RECORD OF TECHNICAL CHANGE

Technical Change No. 2

Project/Job Name Industrial Sites/ Corrective Action Investigation Plan for Corrective Action Unit 261: Test Cell A
Leachfield System, Nevada Test Site, Nevada

Changes to the *Corrective Action Investigation Plan for Corrective Action Unit 261: Test Cell A Leachfield System, Nevada Test Site, Nevada*, U.S. Department of Energy, Nevada Operations Office DOE/NV-515, Revision 0, (DOE/NV, 1998).

Figure 4-2
CAU 261, Area 25, Test Cell A Leachfield Proposed Sampling Locations

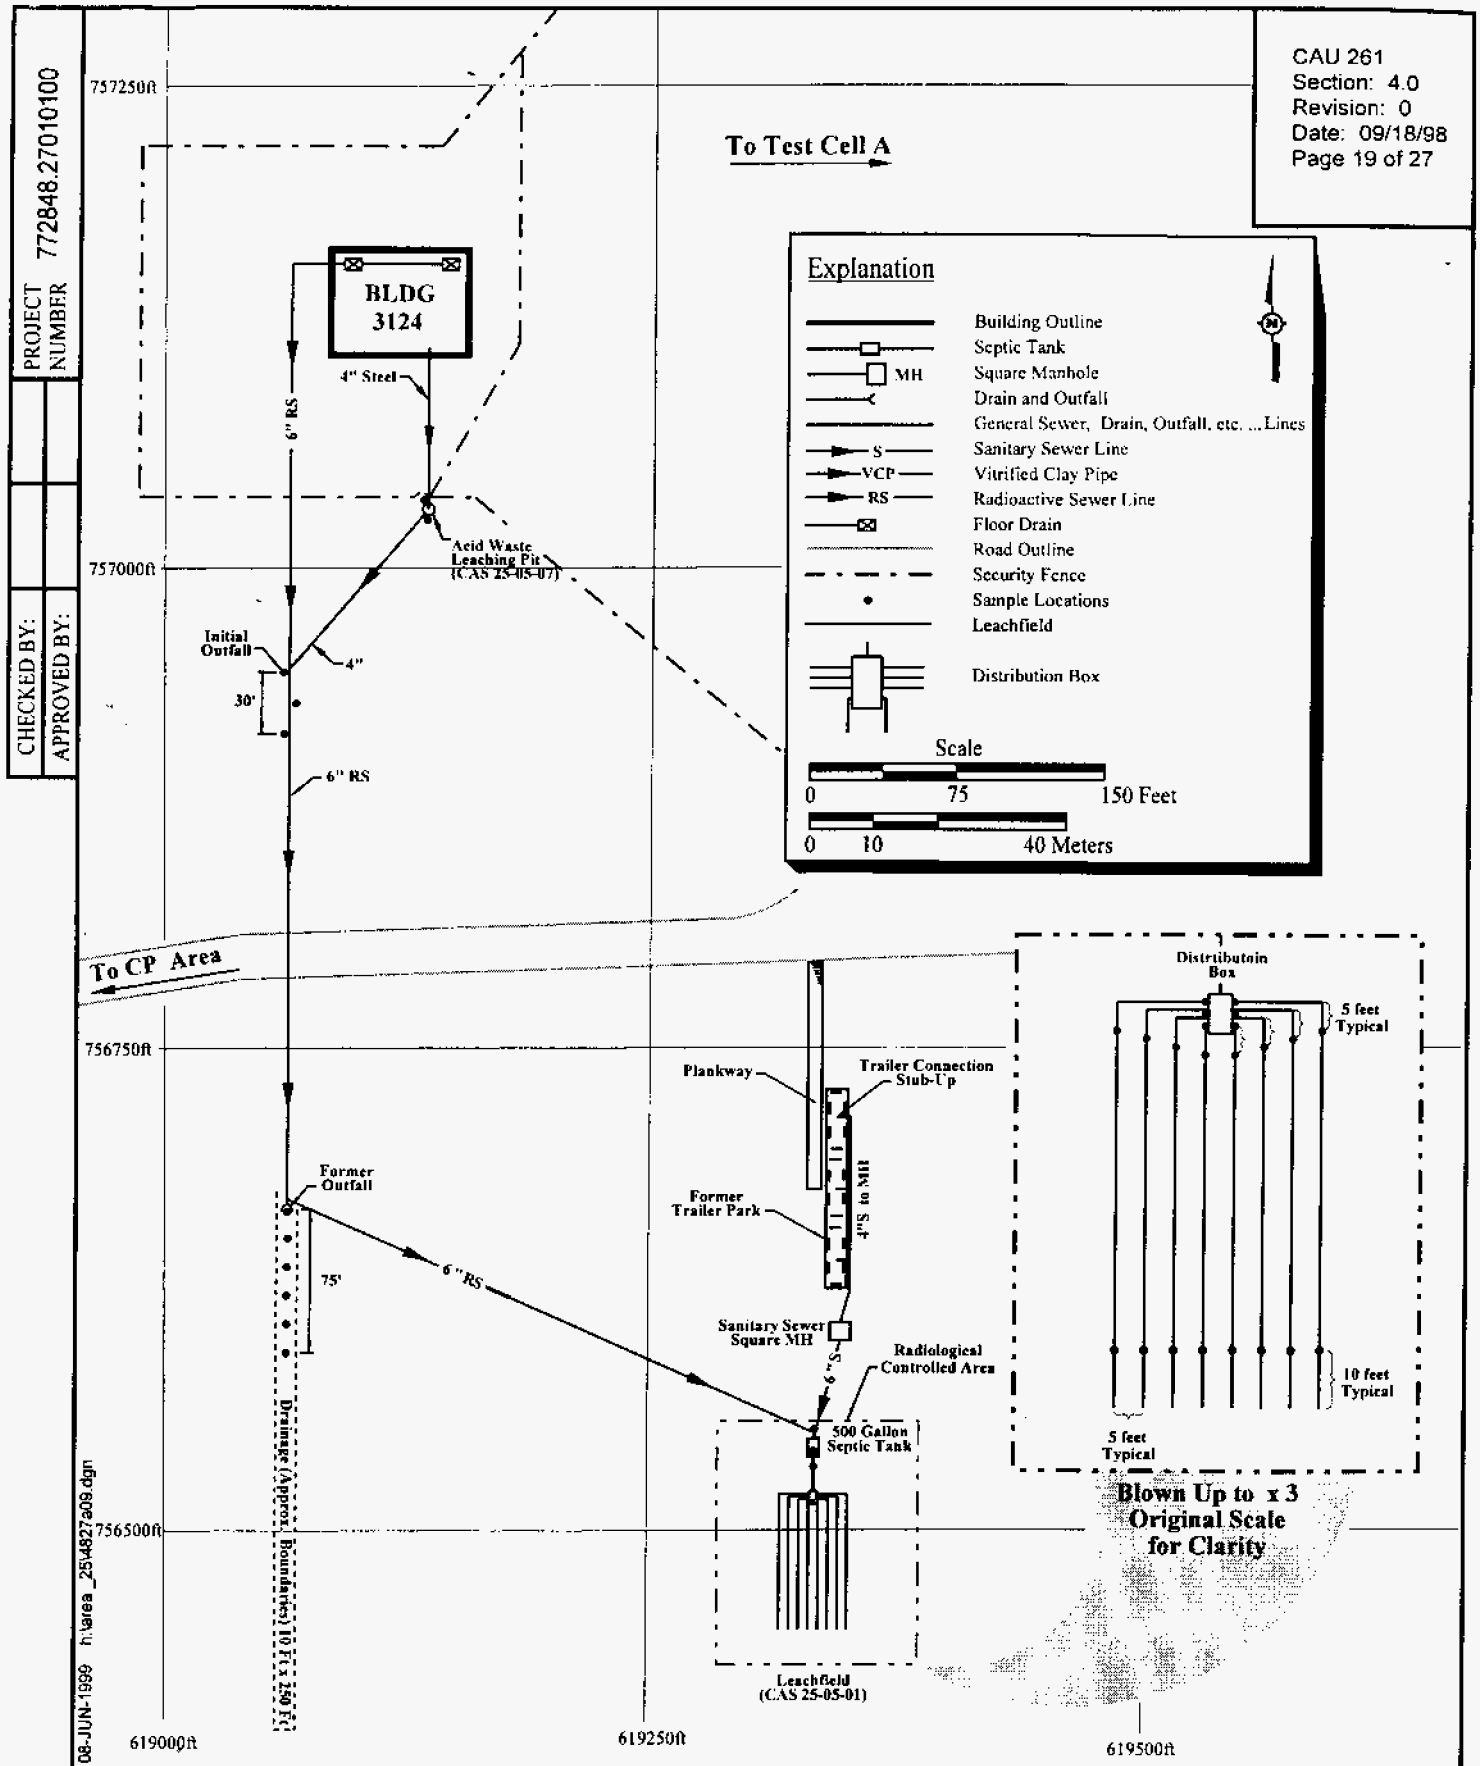
Page 19, Remove existing Figure 4-2 and replace it with the updated Figure 4-2 that shows the leachfield piping configuration based on limited excavation of the leachfield.

Justification: The core barrel hit refusal during the investigation which resulted in the second planned sampling depth being modified. The leachfield piping configuration was not as expected, resulting in the sample locations being modified.
